Modification Recommended Service Note

11713E Attenuator / Switch Driver

Serial Numbers: MY60050108 to MY61410384

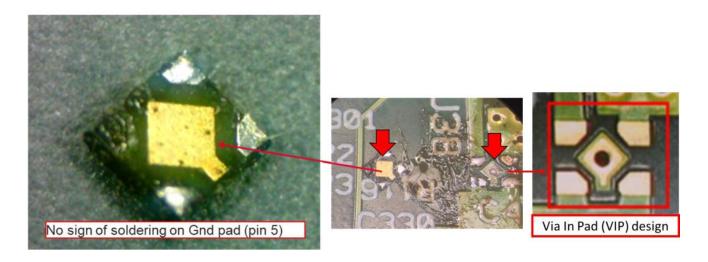
The instrument is unable to boot up and is stuck on the boot-up screen as follows. It is not functioning.

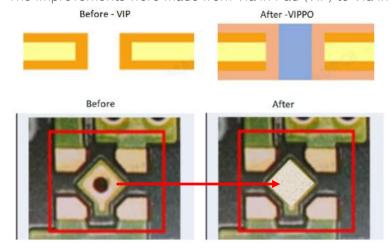
Failure analysis had indicated defective on P0600-63004 board where insufficient solder was observed at 2 locations. The insufficient solder was due to Via in Pad (VIP) where the melted solder had flown to the secondary side of the PCB.

The improvements were made from Via in Pad (VIP) to Via in Pad Plated Over (VIPPO) as per below.

The improved PPMC board have Serial number P06006300423**2413**00007 onwards.

Replace PPMC board P0600-63004 with PPMC board serial number P06006300423**2413**00007 onwards where 13 is the work week and 24 is the year.
